### **Powerco's submission on EDB DPP4 Draft Decision**

# Powerco response to DPP4 draft decision

Figure 1 & 2 - Average planned SAIDI and SAIFI for non-exempt EDBs

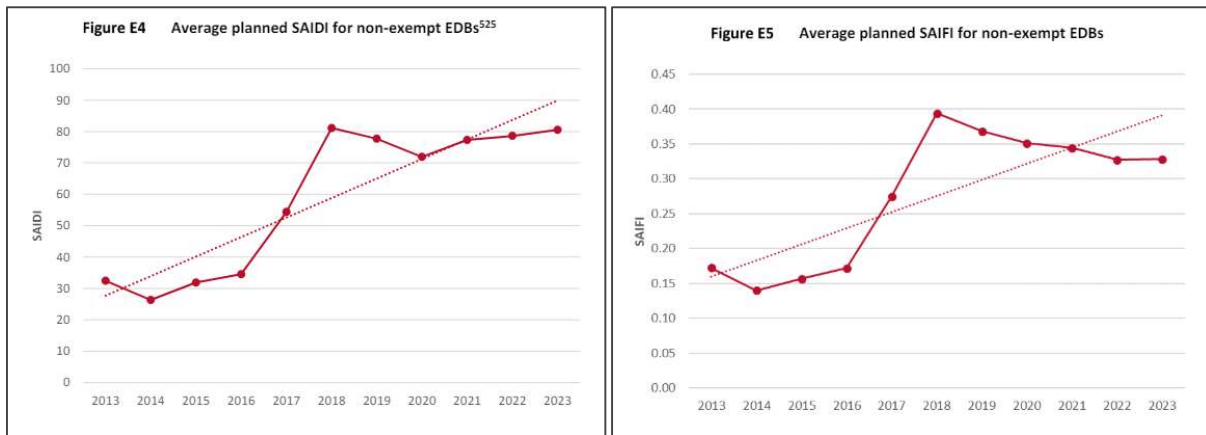
101. Failing that, should the Commission maintain the seven-year reference period, we recommend excluding data from 2017 for the final decision, resulting in a 7-year reference period of 1 April 2018 – 31 March 2024.

The 2017 data does not accurately reflect planned interruption practices employed by EDBs, which coincides with safety led (WorkSafe) move away from live line work. This is illustrated in figure 1 and 2 below, where 2017 data is significantly below the average planned SAIDI and SAIFI for EDBs since 2018.<sup>28</sup>
